SINGAPOREAN NOTICES TO MARINERS

NEW EDITION SINGAPOREAN CHARTS TO BE PUBLISHED ON 14th JANUARY 2026

NOTICES TO MARINERS AND CHART CORRECTIONS

CORRECTION NO.	SNM EDN NO.	LAST CORR N NO.	CHART NO.	Location on Chart		
104 & 105	12	101	GSP1/SP1	X

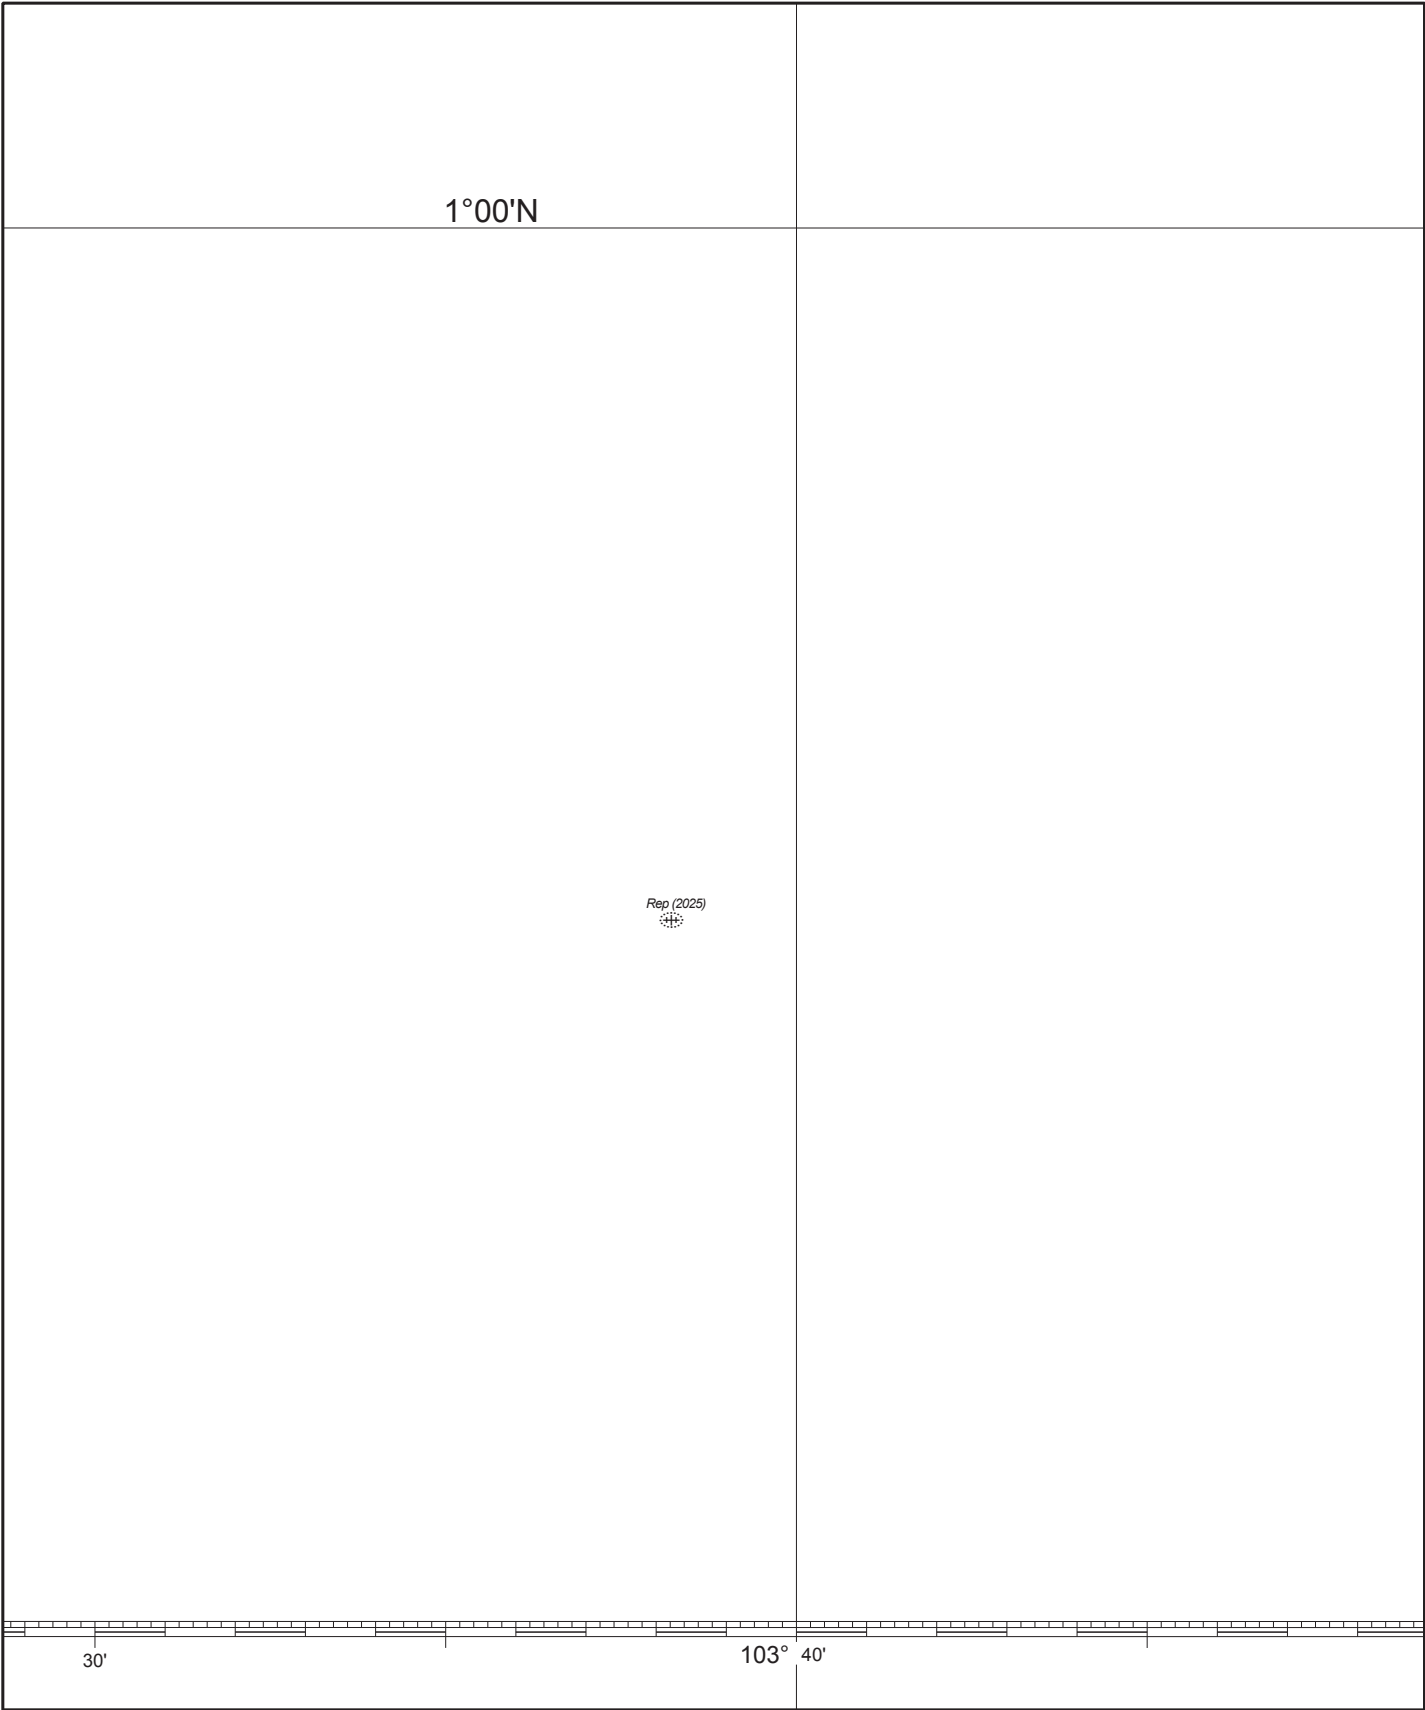
GSP1/SP1 9 Ed 15/01/25 Last NM 101/2025 (Maritime and Port Authority of Singapore) ***NM 104/2025**

Insert  1°18·12'N 103°37·00'E

*Fl(2)10s, ISO* 1°18·13'N 103°36·95'E

(Maritime and Port Authority of Singapore) ***NM 105/2025**

Delete limit of working area, pecked line, joining: 1°13·40'N 103°39·37'E
1°13·30'N 103°38·50'E
